RE: Saranam Golf Course & Montano
4701 Montano Rd NW
Grading and Drainage Plan
Engineer's Stamp Date: 2/15/2022
Hydrology File: E11D013B

Based upon the information provided in your submittal received 2/16/2022, the Grading & Drainage Plan **is not** approved for Building Permit. The following comments need to be addressed for approval of the above referenced project:

**RE: Saranam Golf Course & Montano
4701 Montano Rd NW
Grading and Drainage Plan
Engineer's Stamp Date: 1/4/2022
Hydrology File: E11D013B**

**RE: Saranam Golf Course & Montano
4701 Montano Rd NW
Grading and Drainage Plan**

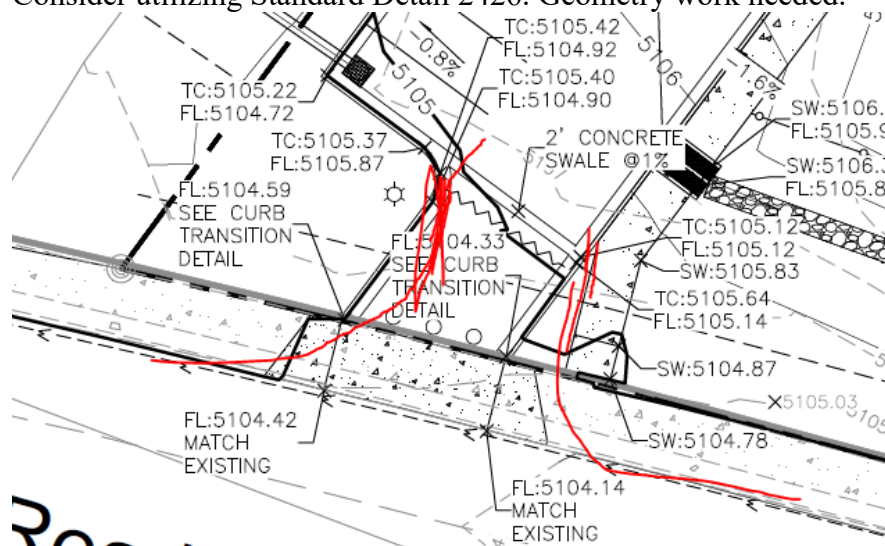
1. Will this entrance work? Have you gotten comments from Traffic Section?
 - a. Consider utilizing Standard Detail 2426. Geometry work needed.

- b. 
- 2.
3. Practically, during construction so many points are not needed and it makes the plans very hard to review.

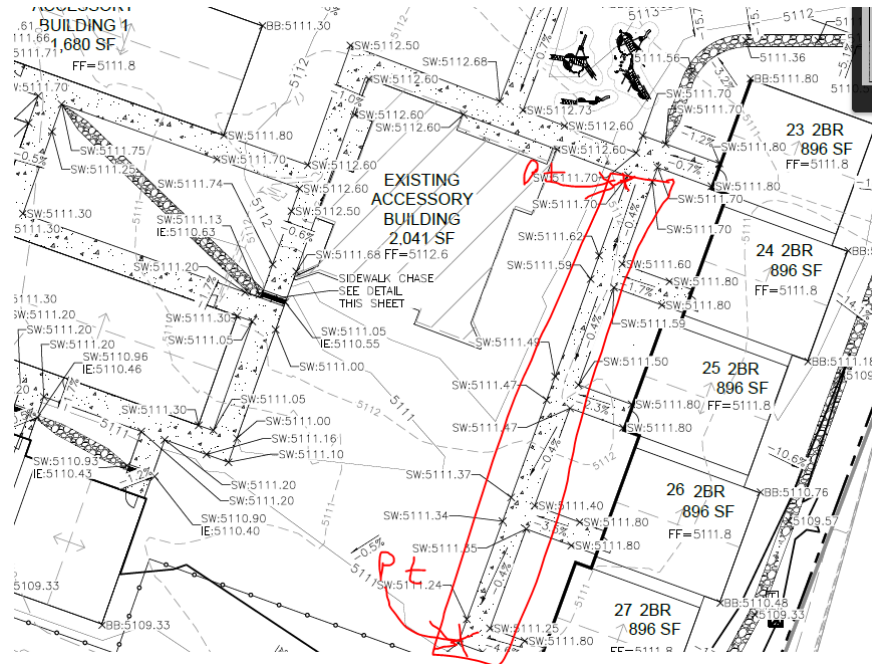
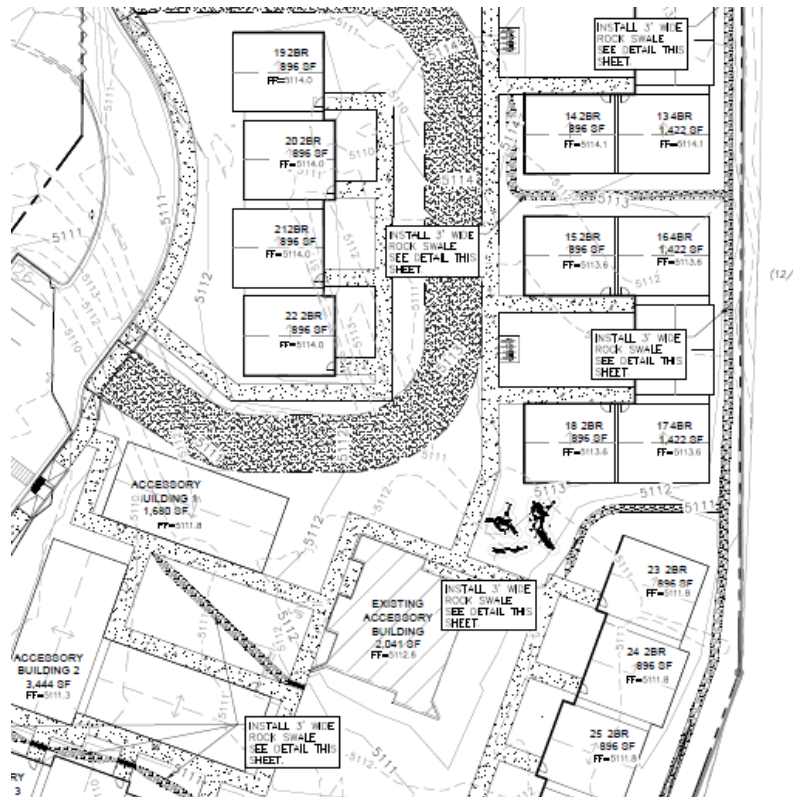
- a.
4. The drafting is very difficult to wrap my head around as much information is on here and makes the plans difficult to review. Please review drafting standards for company if possible. I feel line weights and work with drafting would help make the plans apparent.
- a. What I really would like to know is how water is conveying (e.g. low/High points and grade changes, flow lines. Spots for construction where it makes sense. Contours show the big idea where points will show the small details only when needed)
- b. For example, this section below, I cannot tell what proposed vs. existing contours are without straining my eyes.

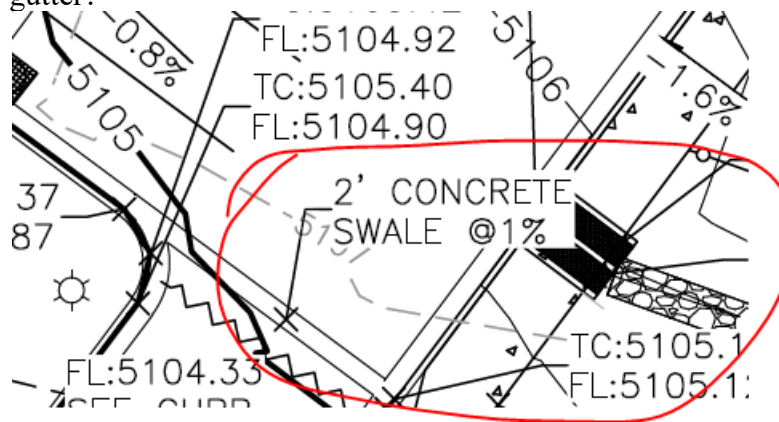
- i.
5. Valley gutter?

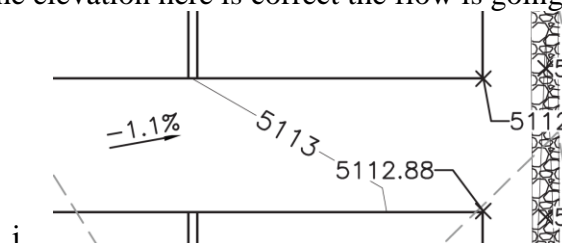
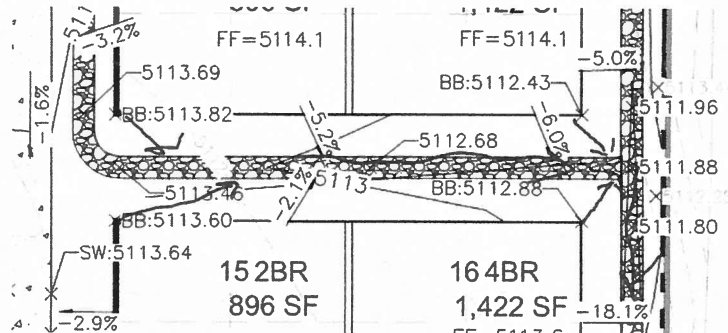
1. The Basin Map does not appear to reflect the same buildings as the G&D Sheets.
 - a. Additionally, it appears flow is directly differently.
 - b. Ensure cross lot drainage is established (easement) if that is the plan and show how this will be routed to the proper location overall. We need to know where the water ends up ultimately.

- b. Provide section and reference to each one.
7. Overall the site needs to have a close review to ensure all of the shown elevations work.
 - a. If the elevation here is correct the flow is going right into the building?

Response: See updated sheet C2.1, basin maps updated to reflect latest changes to site plan and grading. Tract 27-A-2A (Project site) is to drain to the large retention pond located just west of site via an 18" HDPE pipe located within a 20' drainage easement granted under DOC# 202101455 (attached).

Response: Site analyzed to ensure shown elevations work, swales added to areas which may be prone to ponding see below.

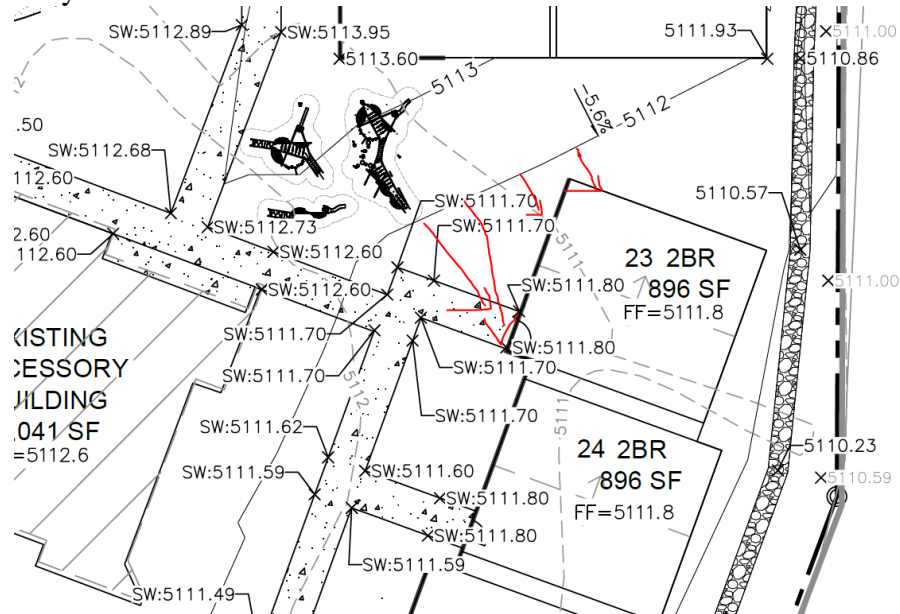
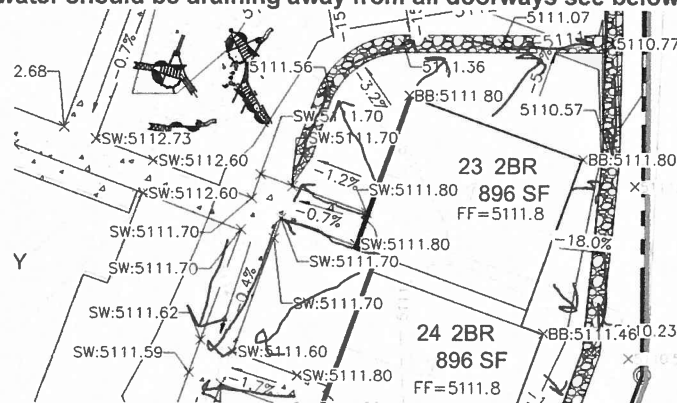
8. Please reference DPM Chapter 6.
9. Please take a second look at everything. See below, it appears flow may go directly into the doorways here.

Response: Storm water should be draining away from all doorways see below.

SHEET C2.3

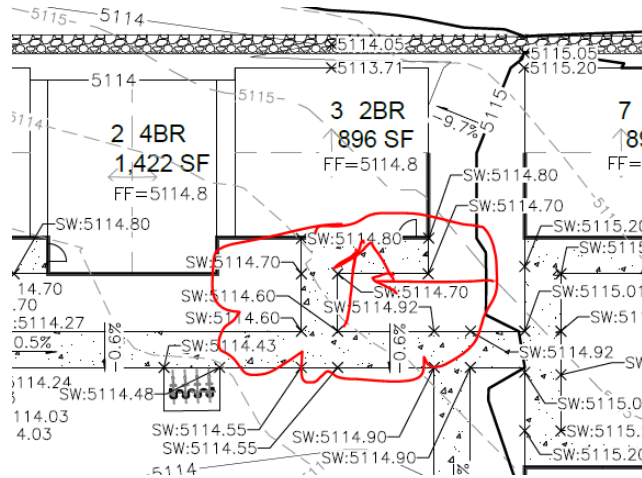
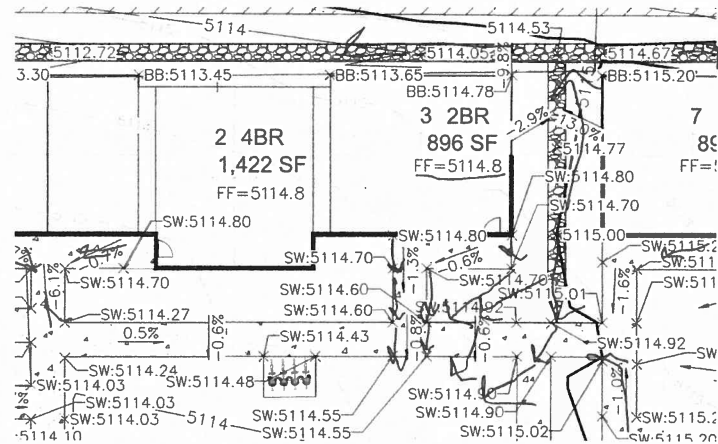
3. Check this area. Appears maybe some ponding and may flow right to the doorway area here.

3. Check this area. Appears maybe some ponding and may flow right to the doorway area here.
Response: Storm water should be draining away from all doorways and does not pond see below.

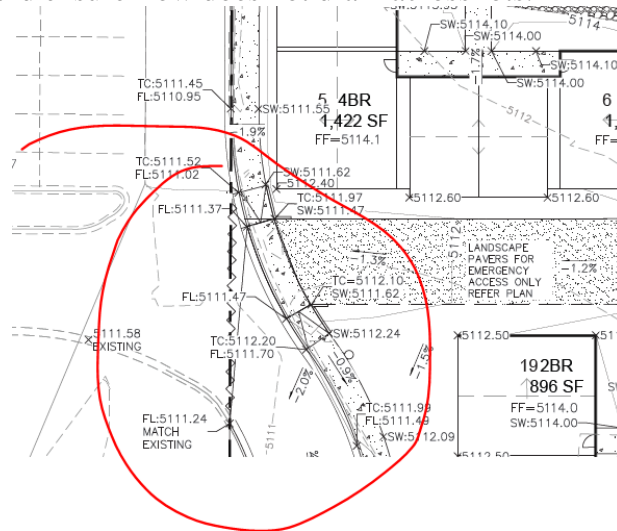
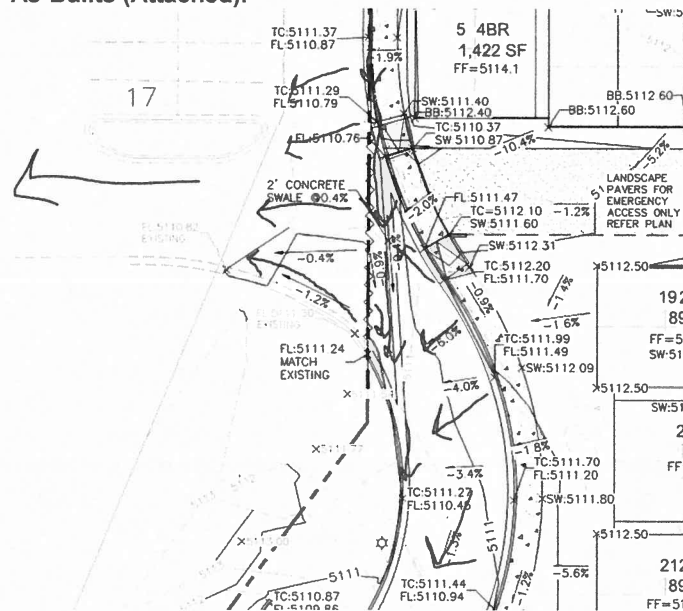
- a.
4. Is this a water block? If so, please provide elevations showing how these grades will work and ensure flow does not drain across lots.

4. Is this a water block? If so, please provide elevations showing how these grades will work and ensure flow does not drain across lots.
Response: Yes there is a water block; flows from the project site are routed south towards the proposed parking area. Flows from the tract to the west flows to the west towards the existing retention pond per As-Built (Attached).

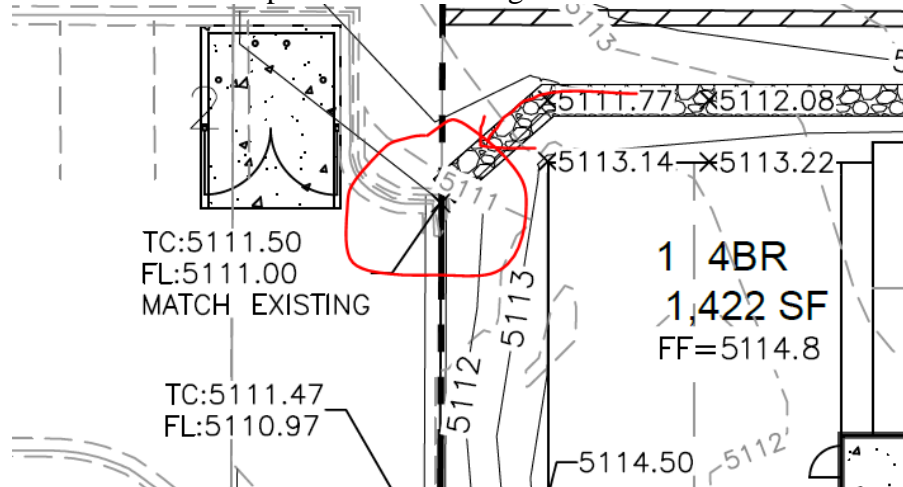
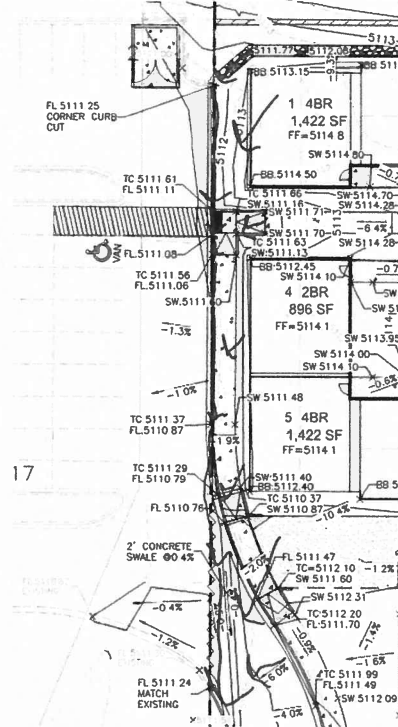
- a.
5. Where does this flow end up? Cross lot drainage?

- Response:** Flows from the project site are intersected by the curb and gutter pan running along the property line towards the proposed southern parking area, no cross lot drainage needed.

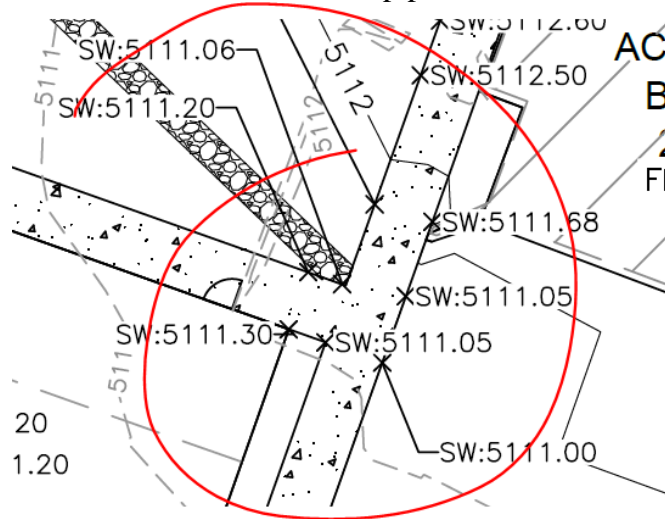
7. How will this work? Will there be a pipe under sidewalk?

- a.
- b. Please show all of these details. As of now it appears this is just a ponding area.
